State of New Mexico  
Energy, Minerals and Natural Resources

Form C-103  
Revised July 18, 2013

| 4. Well Location<br>Unit Letter <u>  O  </u> : <u>  339  </u> feet from the <u>  SOUTH  </u> line and <u>  2089  </u> feet from the <u>  EAST  </u> line<br>Section <u>  14  </u> Township <u>  21S  </u> Range <u>  33E  </u> NMPM County <u>  LEA  </u>                                                                                       |  | 7. Lease Name or Unit Agreement Name<br>DATE 14 STATE COM                                           |

EOG respectfully requests an amendment to our approved APD for this well to reflect the following changes:

Proposed Wellbore

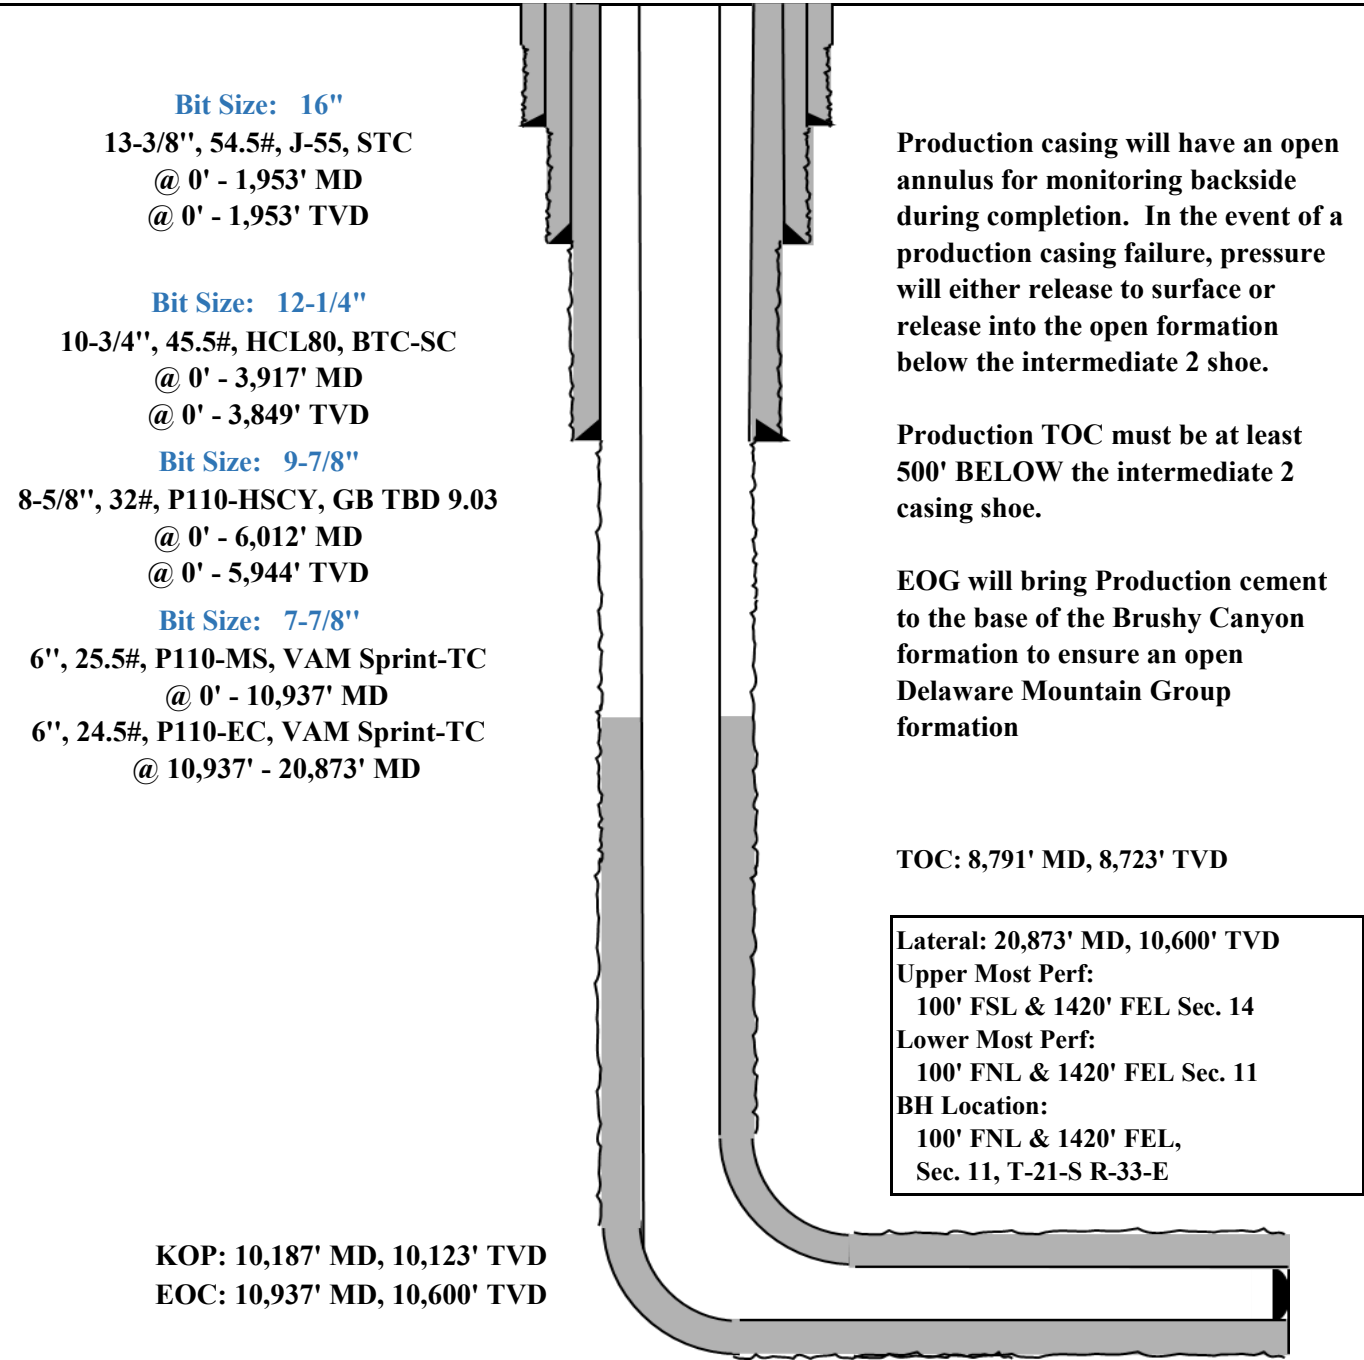
Update casing and cement program to current design.

[Figure E] 4 String – Uncemented Annulus between 2<sup>nd</sup> Intermediate and Production Casing Strings

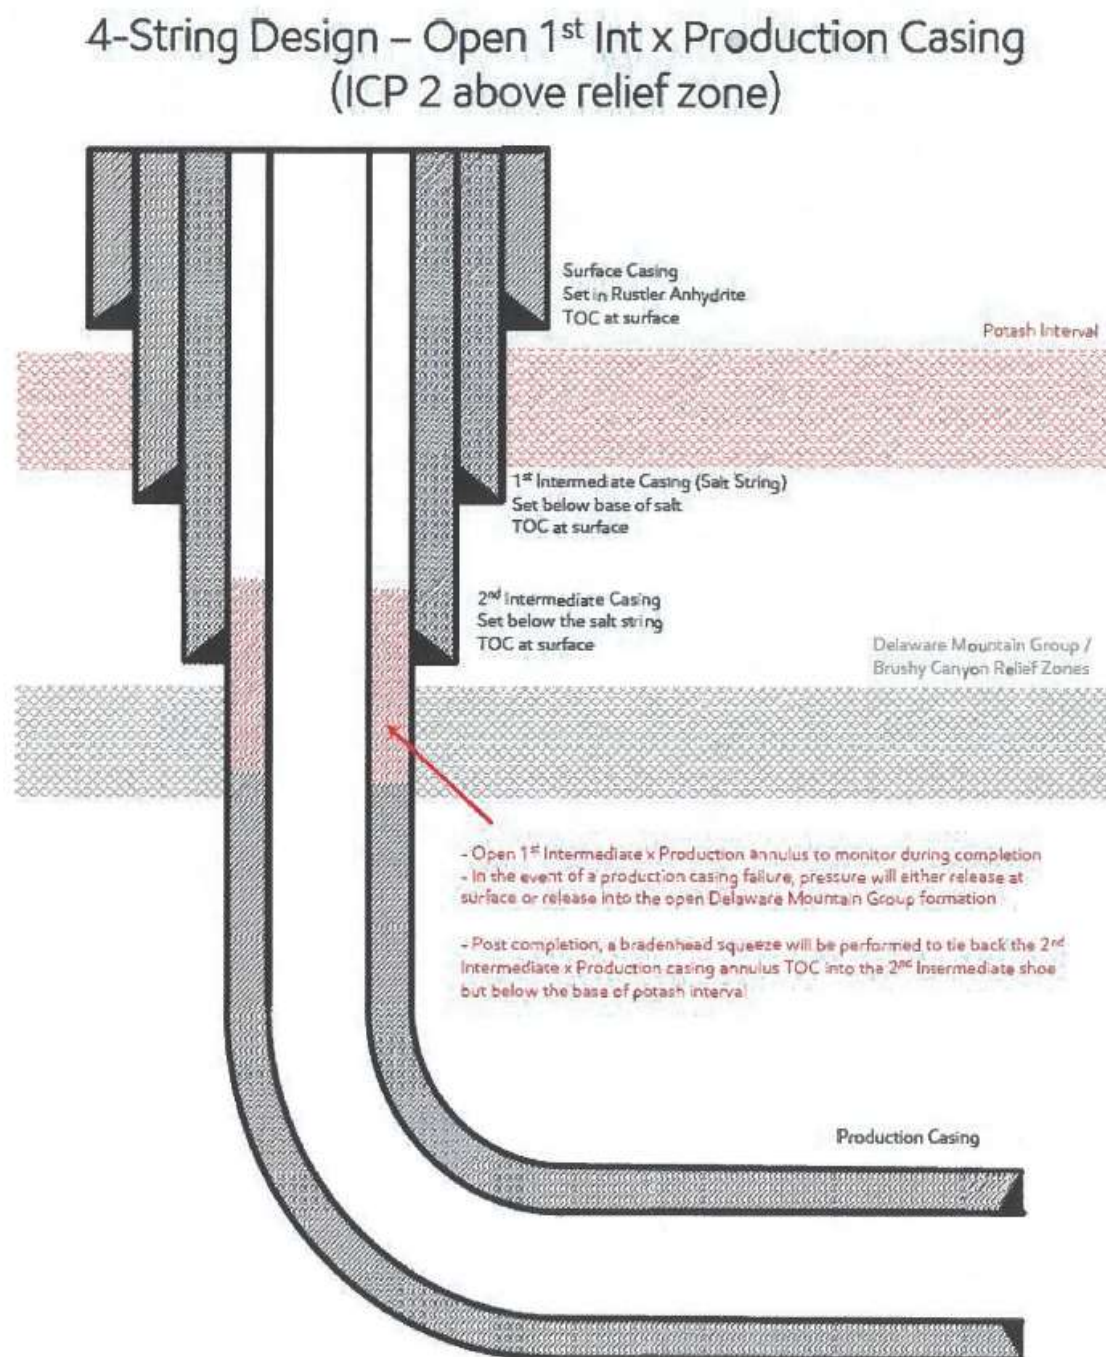
EOG will incorporate method C(5)(c)(iii) for the 4 string designs, leaving the annulus between the 2nd intermediate and the production string open and monitored. The top of production cement will be at least 500 ft below the 2nd intermediate casing point, and ZERO EXCESS will be pumped to ensure no tie-back into the 2nd intermediate.

After hydraulic fracturing operations have been concluded/no more than 180 days after the well is brought online, EOG will bradenhead cement to ensure at least 500 ft of tie-back inside the 2nd intermediate casing, but not higher than USGS Marker Bed No. 126., and at least 50' above the Capitan formation.

See Attached Figure E from R-111-Q for 4 String - Uncemented Annulus WBD.

[Figure D] 4 String – Uncemented annulus between 1<sup>st</sup> and 2<sup>nd</sup> Intermediate casing strings

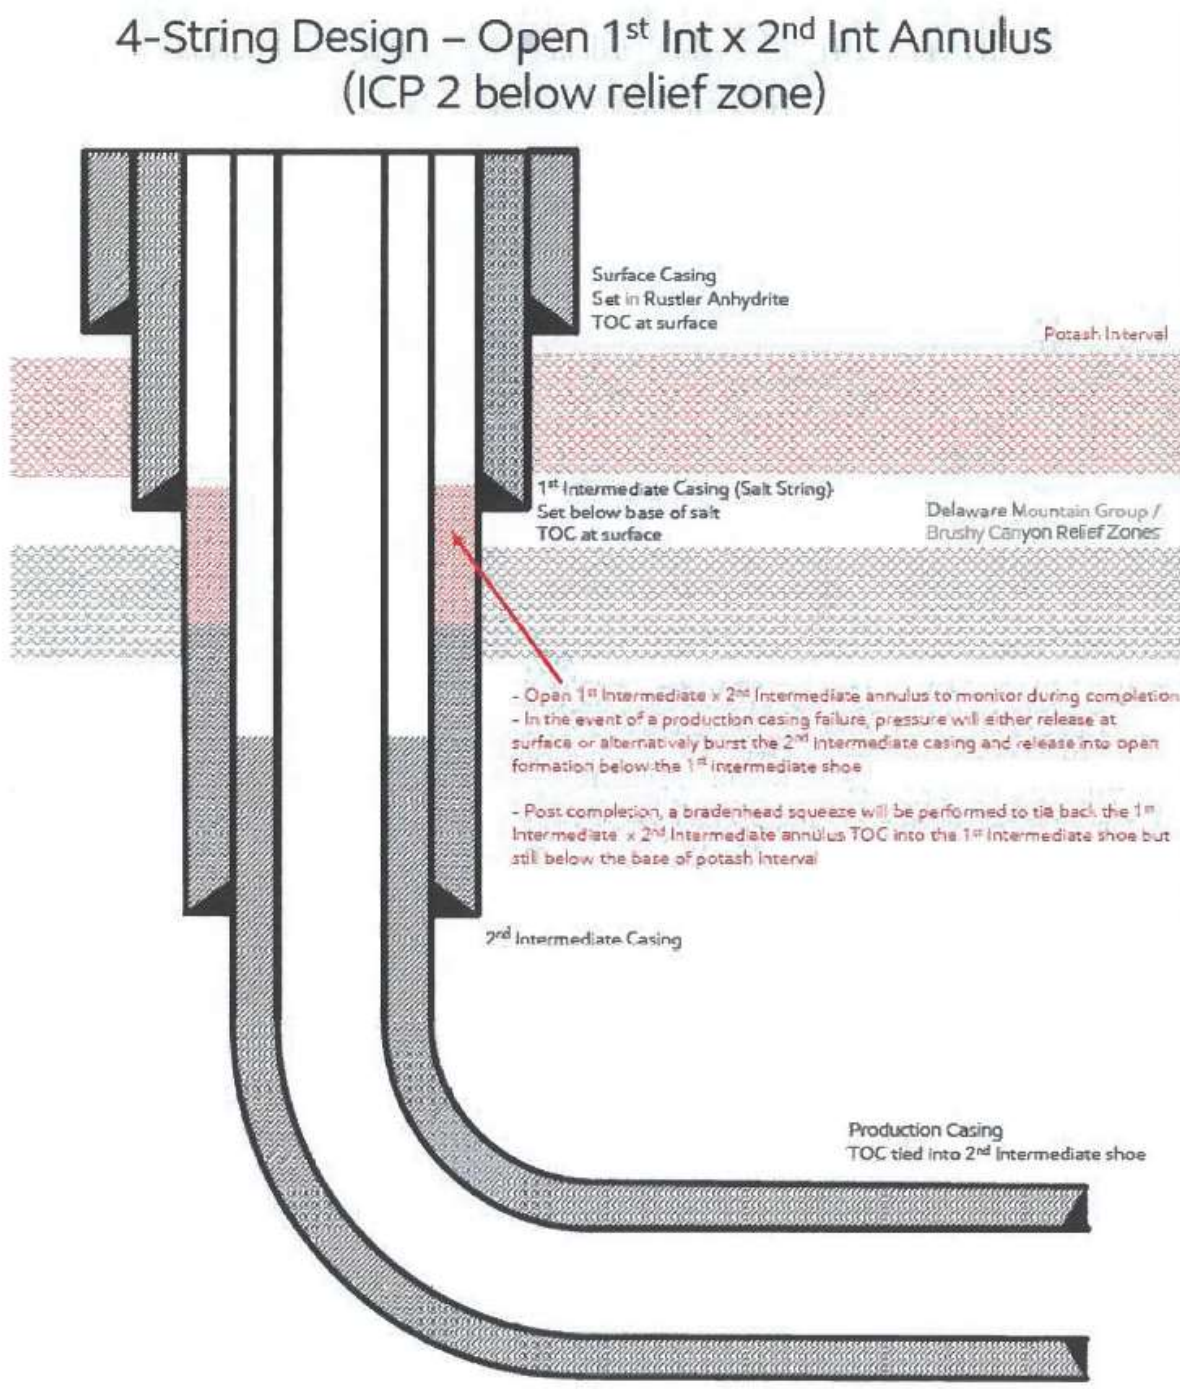
See Attached Figure D from R-111-Q. This design will be modified for EOG's 5 string designs, where the annulus between the 3rd and 2nd intermediate casings will be left open below the 2nd intermediate casing shoe.

| Created By    | Comment                                                                                                 | Comment Date |
|---------------|---------------------------------------------------------------------------------------------------------|--------------|
| matthew.gomez | For future reference, please do not include other R-111-Q designs that are not intended to be utilized. | 11/18/2025   |
